| 8802-3/802.3 REVISION REQUEST 1164 |

STANDARD: IEEE Std. 802.3af-2003
CLAUSE NUMBER: Figure 33C.11
CLAUSE TITLE: Align informative figure with normative text

See attached corrected drawing of 33C.11, Changes are marked with red color.

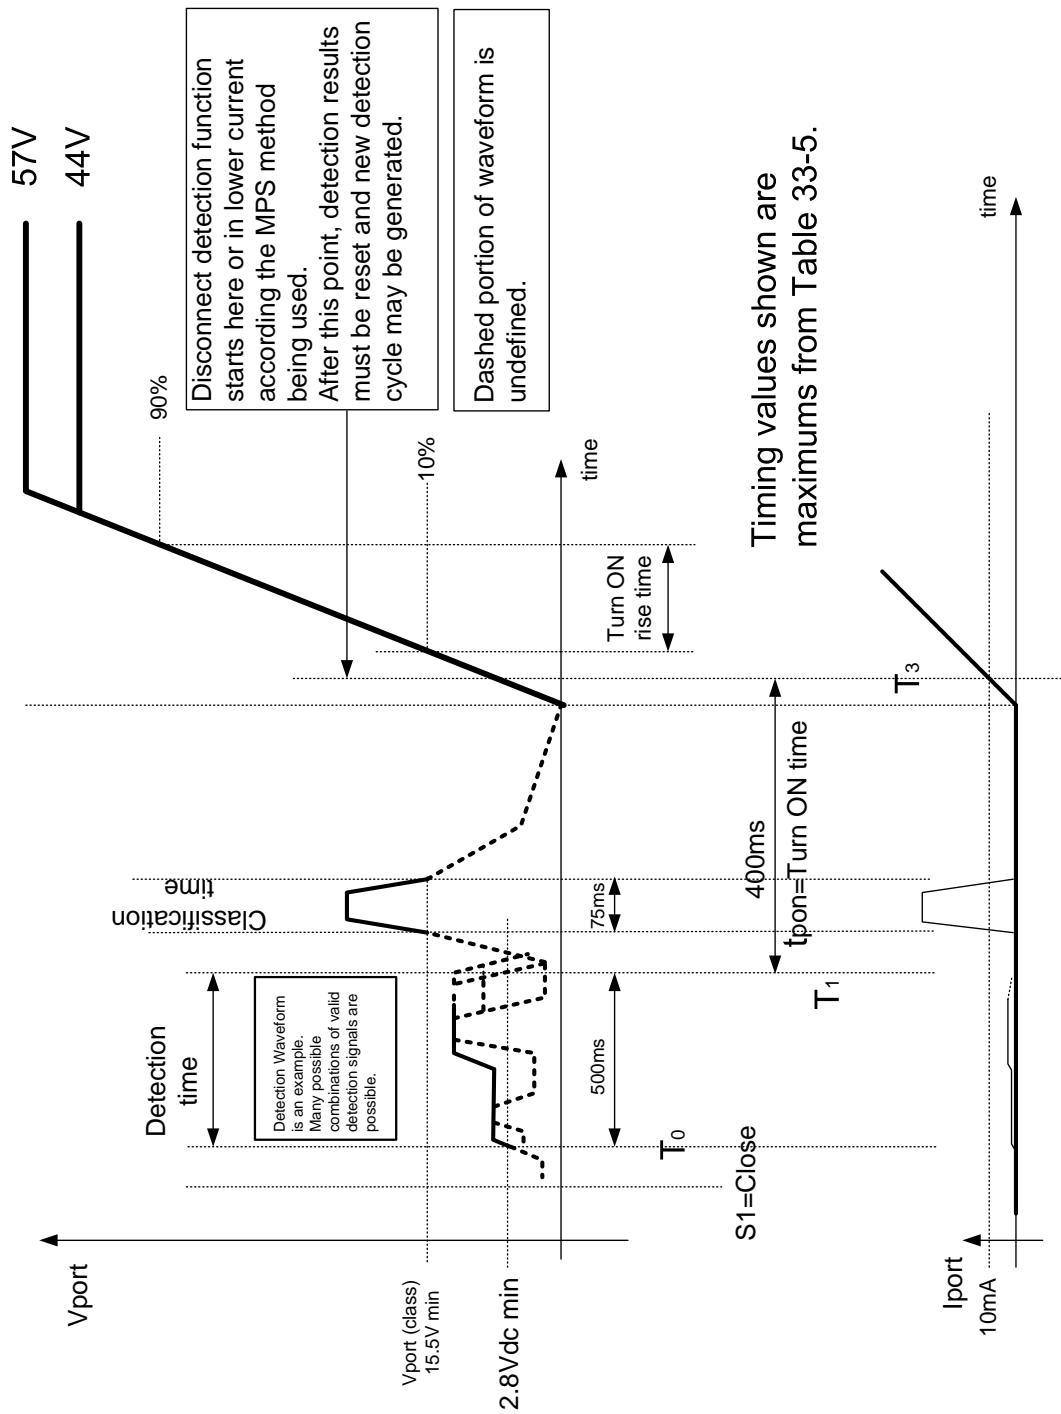
1.1 The current drawing shows that the vertical dashed line that specify the start of the detection time are crossing the detection voltage at zero voltage which is an error according to table 33-2 item 3. It should cross at the 2.8VDC horizontal dashed line.

1.2 The end of the detection voltage can be anywhere as long as Vvalid per table 33 item 3 is kept.

1.3. The vertical lines that shows the classification time duration should be aligned to the min classification voltage.

1.4 The label "T0" and S1="Closed" are located at the same timing point which is an error. T0 is the beginning of the detection time and S1 is the time that S1 in the test setup is closed which happen before T0 in the general case. The label T1 should show the end of the detection timing.

1.5 The label of the Y axis of the drawing "Voltage" should be replaced with Vport which is actually the signals tested at the port.

1.6 The label "Vport (cc)" adds no information to the drawing and should be deleted. "(cc)" is the port nodes according drawing 33C.12 which adds no information.

1.7 Detection and classification signals vs time may be different than the example shown in the drawing and it is convenient to show it by adding the dashed lines to the locations were it is allowed to be different by the spec.

1.8 Iport can't be > 0 while Vport during startup =0. Need to synchronize the voltage and current drawings.

1.9 The drawing meant to illustrate the timing between events that was specified in the standard. Undefined parts were drawn with dashed line.

1.10 Disconnect detection starts when the PSE starts powering the port. The exact point is function of the MPS method being used.

1.11 The use of "must" is incorrect since delay between detections is not specified.

Although figure 33C.11 is in the informative part, it will be helpful for the reader to synchronize the drawing to the spec to avoid confusion which.

1. Change Figure 33C.11 as follows:
 - 1.1 move the vertical dashed line to cross the horizontal 2.8VDC dashed line at the beginning of the detection signal.

- 1.2 move the vertical dashed line at the end of the detection period to a location within the higher section of the detection signal curve.
 - 1.3 Move vertical dashed lines of classification voltage to clearly show classification time interval.

- 1.4 Locate the labels "T0", "S1=Closed" and T1 at the correct locations shown in the attached drawing.
 - 1.5 Y axis label of the drawing should be replaced with "Vport"

- 1.6 Delete Vport(cc) horizontal dashed line and Vport(cc) label.
 - 1.7 Show in the drawing that the example shown is one of many possibilities by marking the parts that may be different by dashed line.

- 1.8 Move Iport curve zero point to line up with Zero voltage of Vport at turn on point as shown.
 - 1.9 Add text box "Dashed portion of the wave forms is undefined"

- 1.10 Change the text in the upper right corner box from:
" Disconnect detection function starts here" To: "Disconnect detection function starts here or in lower current according the MPS method being used."

- 1.11 Change the following text from: "... After this point, detection results must be reset and new detection cycle must be generated."
To: "... After this point, detection results must be reset and new detection cycle may be generated."
